ORDINANCE NO. 781

AN ORDINANCE OF THE MAYOR AND COMMON COUNCIL OF THE TOWN OF PAYSON, ARIZONA, AMENDING PROVISIONS OF THE TOWN'S UNIFIED DEVELOPMENT CODE RELATING TO FLAG LOTS AND THE REQUIRED WIDTH OF THE POLE PORTION OF SUCH LOTS.

SUBJECT: **Flag Lot Pole Width – Ordinance 781, Resolution 2550**

Exhibit B

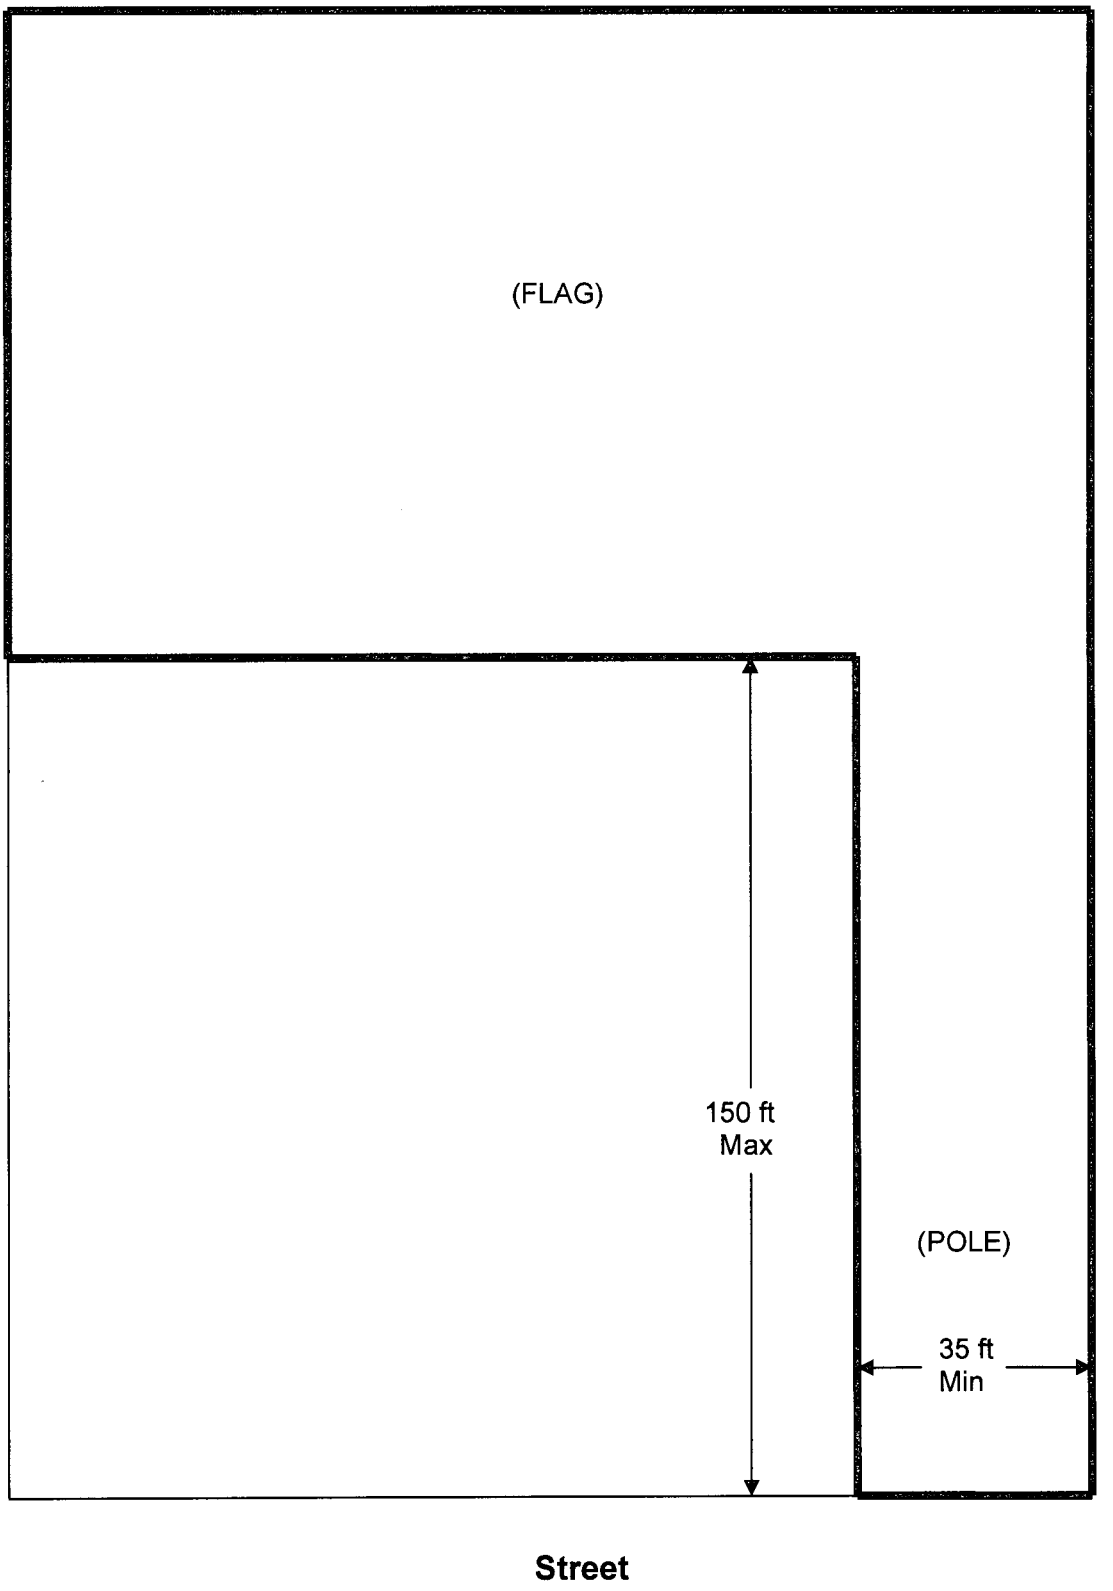
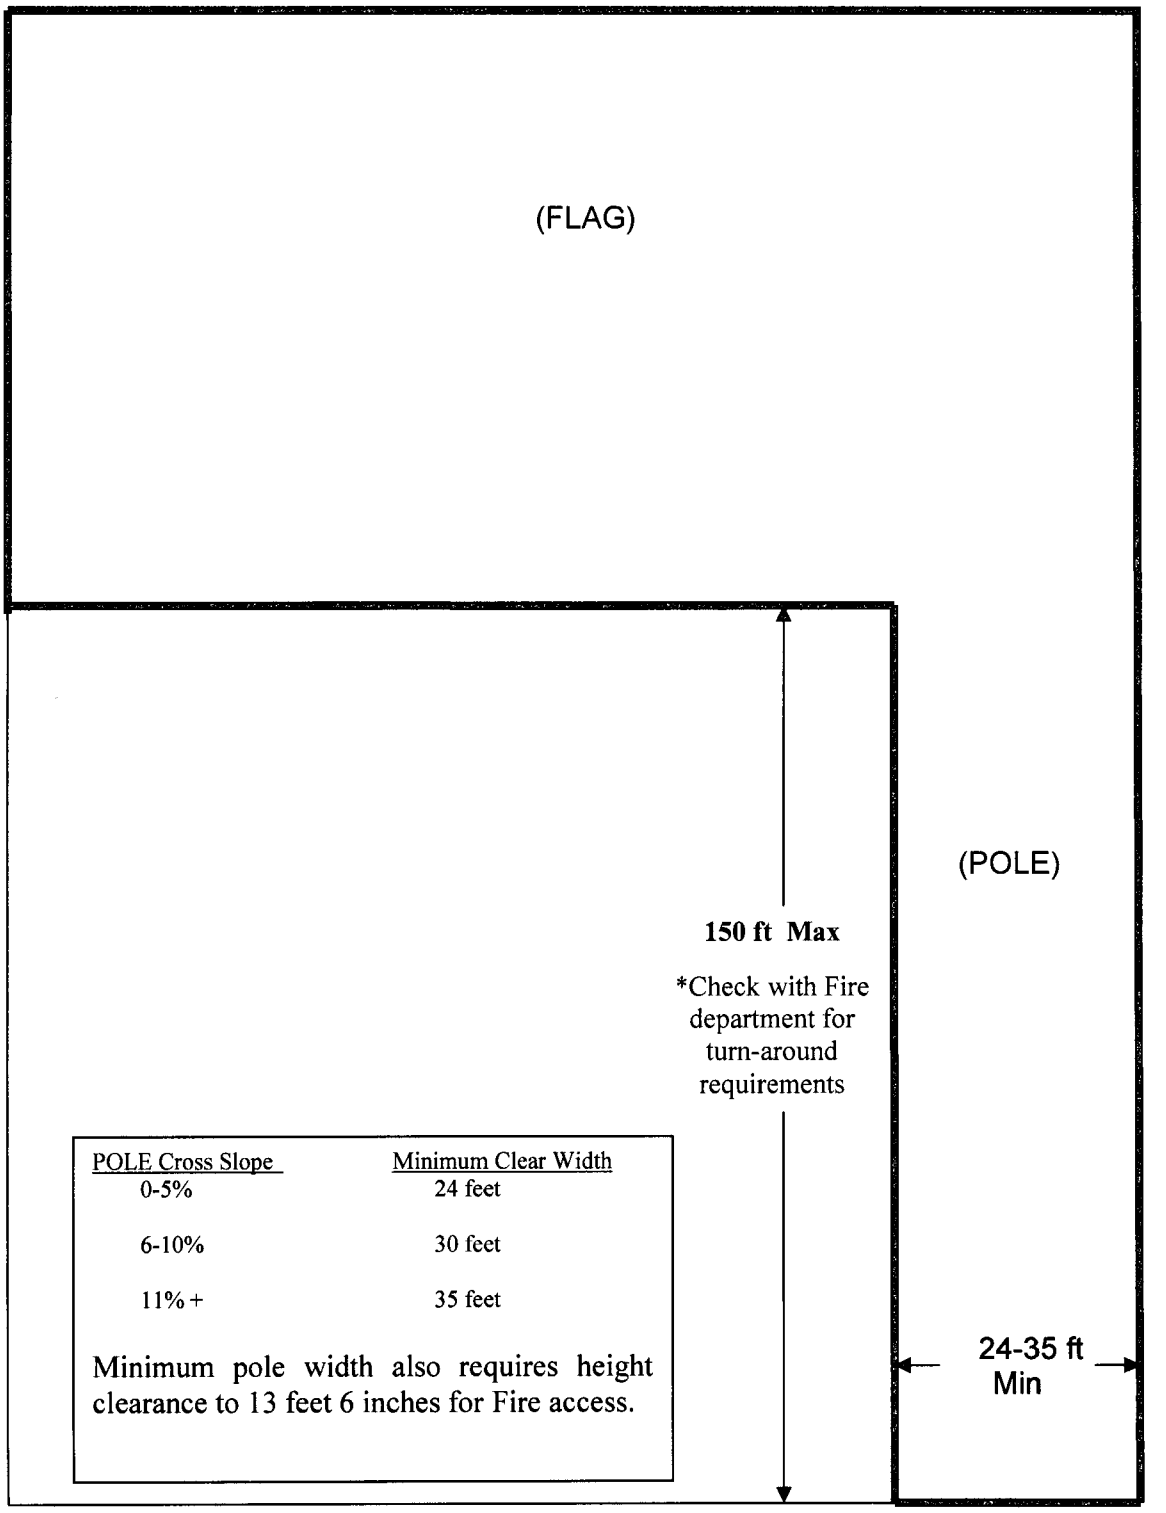
Attached Exhibit A demonstrates the current requirements. Attached Exhibit B demonstrates an alternative to the current code requirements, which could be supported by Community Development, Engineering, and Fire Department staff.

Staff recommended approval to the Planning & Zoning Commission of the applicant's request for an amendment to the current code standards as the proposed minimum pole width of 24' to 35' would provide adequate access to newly created lots.

POLE Cross Slope	Minimum Clear Width
0-5%	24 feet
6-10%	30 feet
11% +	35 feet

Minimum pole width also requires height clearance to 13 feet 6 inches for Fire access.
